PERFORMANCE SPECIFICATION SHEET

RELAY, SOLID-STATE, SEALED, CLASS I, OPTICALLY ISOLATED, ZERO VOLTAGE TURN-ON,
25 AMPERES, 250 V MAXIMUM, 400 HZ, POWER SWITCHING, SPST (N.O.)

This amendment forms a part of MIL-PRF-28750/10C dated 1 February 1999, and is approved for use by all Departments and Agencies of the Department of Defense.

MIL-PRF-28750/10C
AMENDMENT 3

FIGURE 5. Broadband conducted emissions.”

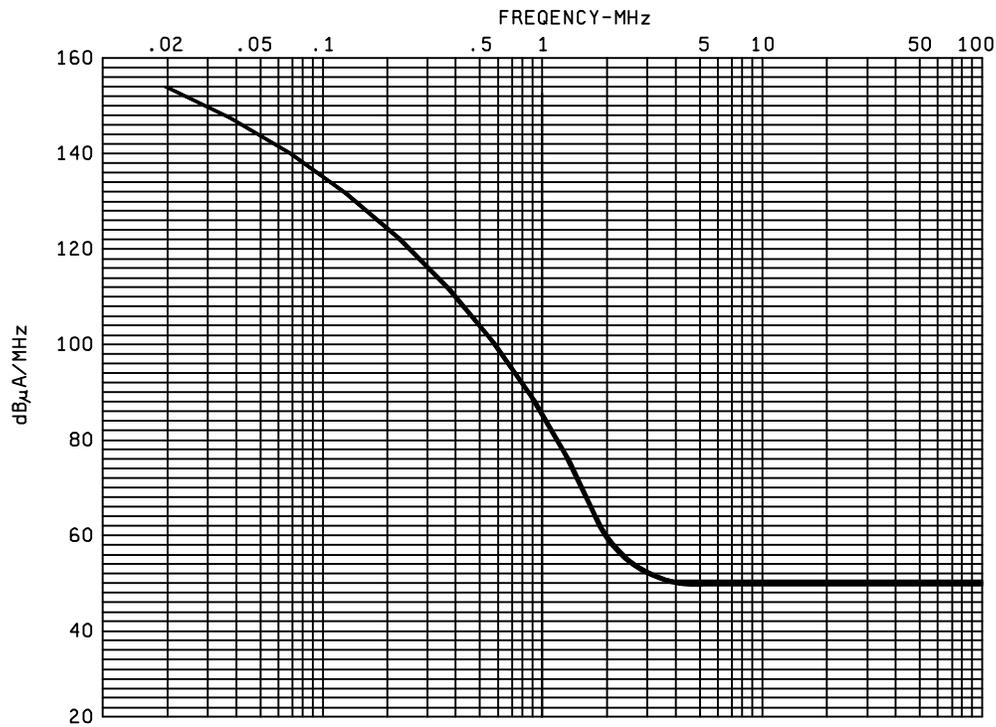
* Add a figure 5:

- * Add a paragraph: "Electromagnetic interference: Maximum broadband conducted emission on power lines with 115 V ac, 400 Hz, 10 amperes resistive load during steady state and switching conditions (see figure 5)."
